Service Bulletin

No. : MZ07-073

Model: SR4001, SR5001

Subject: Software Update Information.

BEFORE MODIFICATION

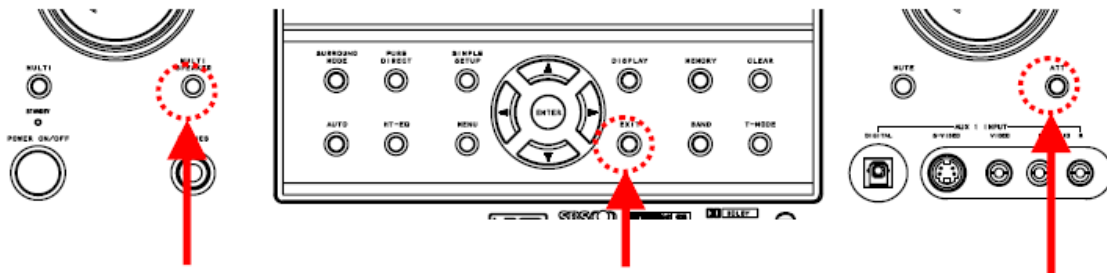
When an abnormality is detected in the POWER AMP, the unit goes into STANDBY with the STANDBY LED flickers every 500m sec. It can never be powered on again with the STANDBY switch or the remote controller, so as not to further damage the POWER AMP. However, when plugged into the AC power

source, it can be powered on again and go into STANDBY after a few seconds, during which further POWER AMP damage may occur.

AFTER MODIFICATION

When an abnormality is detected with the POWER AMP, the unit goes into STANDBY with the STANDBY LED flickering every 125m sec. It has been modified never to be powered on again by any other means than the specific operation mentioned below. (*1):

*1 If the set can not be powered on again by plugging into the AC power source (while the STANDBY LED keeps flickering every 125m sec.), the POWER AMP has been damaged. The power supply can be restored by the following means:
